| 8802-3/802.3 REVISION REQUEST 1118 |

DATE: 31st Oct, 2003
NAME: Eric Lynskey
COMPANY/AFFILIATION: UNH-IOL
E-MAIL: elynskey@iol.unh.edu

REQUESTED REVISION:
STANDARD: IEEE Std. 802.3ae-2002
CLAUSE NUMBER: 48.2.4.2
CLAUSE TITLE: Idle ||I||

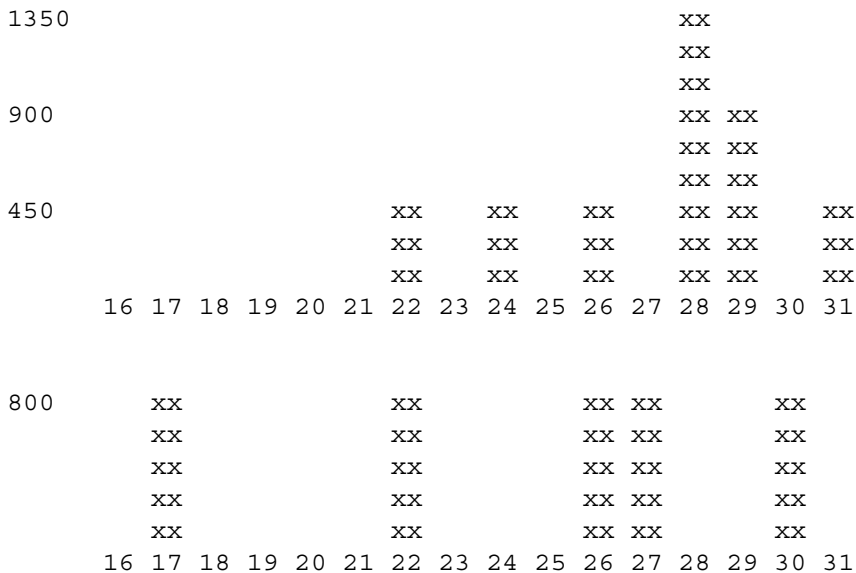
Within bullet item (d) remove the word uniform, allowing the sentence to read "...r is a randomly distributed number between 16 and 31..."

A bit that chooses between ||K|| and ||R|| is produced during every clock cycle. The counter that determines when it is time to send an ||A|| is only evaluated and reset every 16-31 clock cycles. When the A_CNT variable reaches zero, an ||A|| is sent and a new value is loaded into the counter. The four bits loaded into the counter can take on any value from zero through fifteen, and these are combined with an MSB that is always high, thus initializing the counter to 16-31. This counter will then start to count down, decrementing once for every clock cycle. While this counter is decrementing, the pseudo-random generator is continuing to shift through its 127-bit cycle, and ||R|| and ||K|| codes are being transmitted. Thus, the bits being fed to the A counter are not being fed continuously, but only after the expiration of the current A counter.

If a separate pseudo-random generator existed that only provided a new value upon the expiration of A_CNT, then the next sequence would get shifted into the counter and no possible combinations would be missed. If the pseudo-random generator generated its first four output states as W1, W2, W3, and W4 (where each Wn is 4-bits in length and takes on a decimal value between 0 and 15, inclusive) then the A counter would be initialized with W1+16. After A_CNT expired, which would be W1+16 clock cycles, the new value of the counter would be set to W2+16. This same process would then continue through all 127 different combinations: W4...W127.

However, this is not what happens within a device with a single random number generator. If there is a single pseudo-random generator, the A_CNT will only get initialized after the previous A_CNT has expired. Since the pseudo-random generator is continuously running to pick between ||R|| and ||K||, the A_CNT will not be initialized with state WX+1 if the

current state is WX, as was shown in the previous paragraph. If A_CNT is originally initialized with WX, then the next state would be W(WX+16). By not sampling the pseudo-random generator after every clock cycle, not every possible value output by the pseudo-random generator will be observed.

The plots on show simulations of what the $||A||$ spacing would actually look like when the pseudo-random generator is sampled in this manner. The first plot shows the distribution of $||A||$ spacing for the X^7+X^6+1 polynomial, and the second plot uses the X^7+X^3+1 polynomial. The x-axis shows the number of columns between consecutive $||A||$ columns. The y-axis shows the number of times that $||A||$ spacing existed. For each simulation, 4096 trials were done. It is clear that after several thousand trials, there are many spacing values that have not been used, thus making it impossible to have a uniformly distributed spacing.

The standard currently defines that the A spacing be uniform randomly distributed between 16 and 31. A brief survey of 6 implementations of this PCS showed that 4 had a distribution similar to one of the two plots that are shown above. One had a uniform distribution, and one had a distribution that was neither uniform nor fitting the above plots. Removing the word "uniform" should allow for both uniform and non-uniform implementations to exist provided that they are based on one of the two defined polynomials.

- d) Each ||A|| is sent after r non-||A|| columns where r is a ~~uniform~~ randomly distributed number between 16 and 31, inclusive. The corresponding minimum spacing of 16 non-||A|| columns between two ||A|| columns provides a theoretical 85-bit deskew capability.
